STAFF REPORT: 09/10/2025 REGULAR MEETING

APPLICATION NUMBER: HDC2025-00547

ADDRESS: 3751 LESLIE

SCOPE: REPLACE STEEL WINDOWS WITH ALUMINUM-CLAD WINDOWS, REPLACE FRONT DOOR (WORK COMPLETED WITHOUT APPROVAL)

Staff photo, 08/28/2025

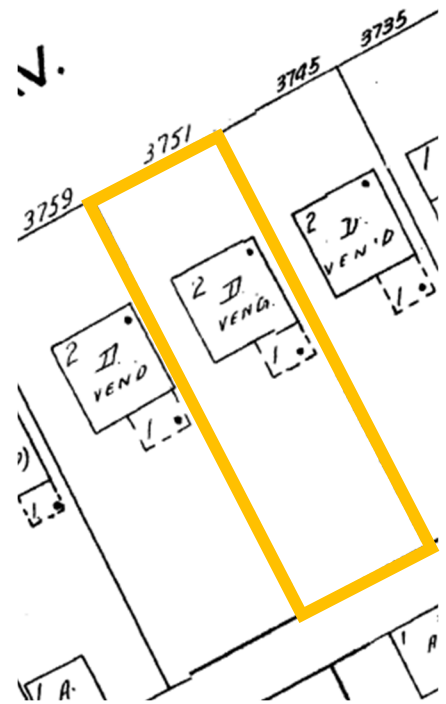
The installation of the front façade replacement vinyl windows and front door were installed without the approval of the Historic District Commission, which has impacted the property's historic character.

Designation photo by HDAB, 1999

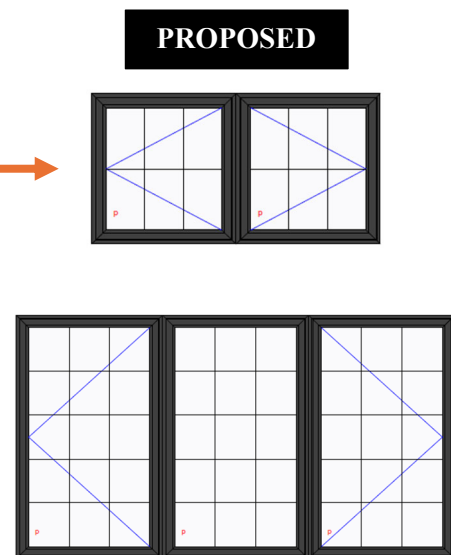
- The three (3) historic steel windows that were removed and replaced with vinyl windows were unambiguously character-defining as they were steel casement windows, and as described in the Elements of Design that “houses built later in the period of development sometimes have individual windows which are balanced or somewhat wider than tall; such a window is often the main opening of the first floor front façade.”

- The current application proposes installing aluminum-clad wood windows. Staff notes that, as the vinyl windows were installed without approval, **the Commission's review is to determine if the removal of the distinctive-character defining steel and installation of aluminum-clad wood windows meets the Standards; this application is not for the comparison of vinyl windows to aluminum-clad windows.**

- Due to the difference in strength of steel and wood, the dimensions of the aluminum-clad wood frames and muntins/grilles will likely not match the thinness of the historic width and profile of the steel window frames, muntins, and mullions.

- As the windows were removed without HDC approval, the scope of work that would meet the requirements of the historic ordinance (Section 21-2-59(e)), is the fabrication and installation of new steel-framed windows with an identical pattern and operation with dimensions that match the historic windows.

- The historic steel windows were distinctive, character-defining features and not proven to be beyond repair.
- The proposed windows are not in-kind matches to the historic windows at this property, required to restore the pre-violation condition.

Staff photos of nearby houses to the subject property, 08/28/2025

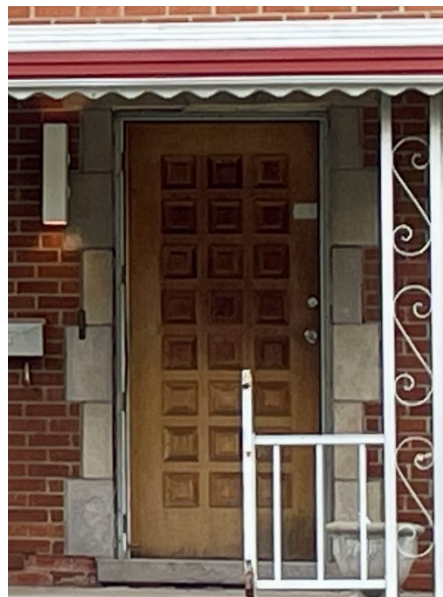
- It is staff's opinion that the proposed front door is inappropriate, especially given its reference to earlier style doors with the multi-panel style and faux-beadboard pattern.
- Staff considers the front door a key feature of the dwelling's façade, especially considering the Art Moderne design and the clean simplicity of the International style with this house.
 - Mid-century era doors often featured clean lines, simplistic designs, and sometimes asymmetry and/or window cutouts.
- During field observations for the Russell Woods-Sullivan Historic District, staff identified houses of a similar architectural style with historic front doors.

- Architectural features/elements copied from incompatible ornamental styles (like the proposed door) are not appropriate here, and create a false sense of historic development, in direct contradiction to the NPS's Standards for Rehabilitation, Standard #3.

- A new design for the replacement door shall be selected and submitted to staff for review and approval.
